DESIGN REVIEW & PRESERVATION BOARD

LOCATION: 7485 Elder Creek Road

PROPOSAL: Applicant proposes to construct a single story Hindu Temple with domes.

82-177

FLOOR PLAN

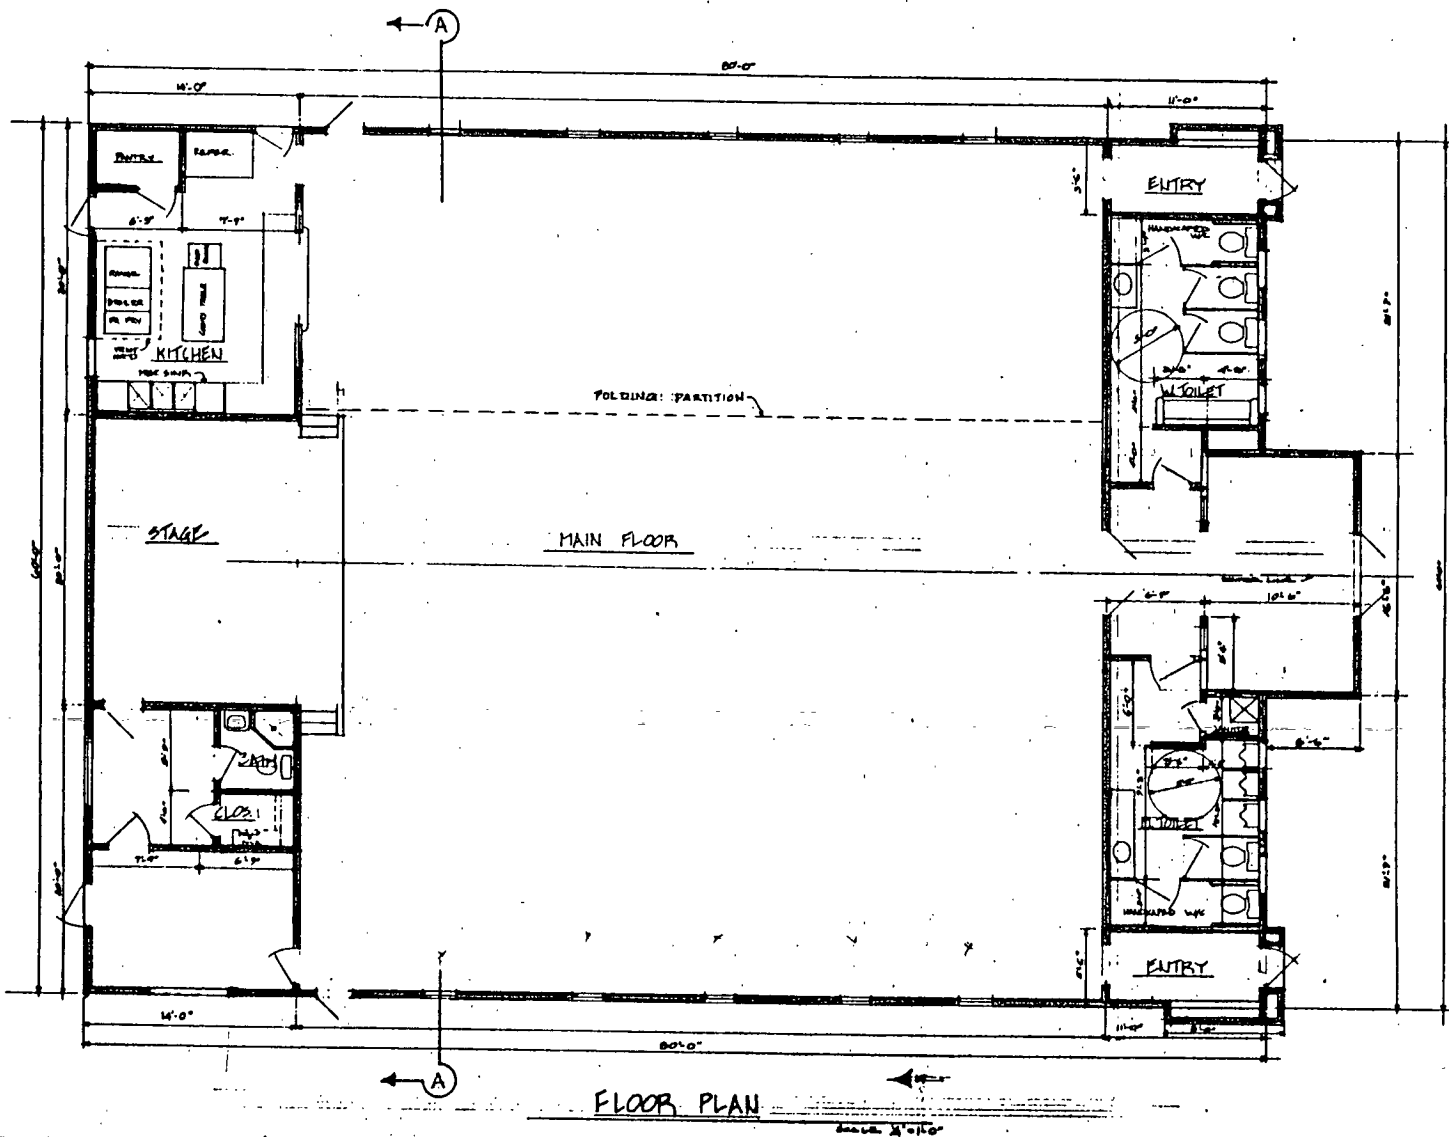
E) Building Design: Staff feels that the changes have been made to the structure which help to unify the four elevations of the building.

F) Roof: The change of the roof line from one which emphasized the roof and eave line (See City Planning Commission Report) to one which now projects a stronger feeling of the horizontal movement of the side walls helps to tie the side elevations to the front and rear elevations. Staff feels that a further design change by the addition of a parapet wall at the east, west and north elevations would help to continue to unify the buildings four elevations. The ~~gable door~~ *gable ROOF* should not be a visual element of the building.

G) Domes: The change from the faceted surfaced domes as shown on the City Planning Commission submittal to Ogee Domes enhances the character of the building. The round base or drum of each dome rests on an inset square terminus fascia of each of the three towers. The fascias have a round design motif indicated. This surface decoration needs to be worked out further. The architect might wish to use a more geometric design which could relate to the lattice work found between the side towers and the center tower.

H) Walls: The step parapet of the front elevation works well with the three towers and provides a transition between the two side towers and the main tower. The change of surface material from light green brick to white plaster and the change in surface alignment will add to the visual character of the structure. The same theme is carried throughout on the other three elevations. The continuation of the parapet above the eave line on the east and west elevations would be helpful. Stepping the parapet at the north elevation would hide the ~~castle~~ *gable* end of the roof.

STAFF RECOMMENDATIONS: Staff recommends that the applicant revise the project drawings to meet the following conditions:

1. Site plan to show required parking layout.
2. Landscaping plans to show proposed plant material and layout, final landscaping and irrigation plans to be reviewed and approved by staff.
3. Site plan to show 6' high masonry wall on east property line to the depth of of the required parking area. Landscaped planters along east and west side of parking and driveway area to have 6' wide, inside measurement, planter.
4. Sign(s) to be reviewed and approved by staff.
5. Trash storage area to be provided. Area to be screened. Utility boxes and all A/C units to be screened from view.
6. Changes in building design to comply with concerns of staff as outlined under "Staff Evaluation: Building Design."
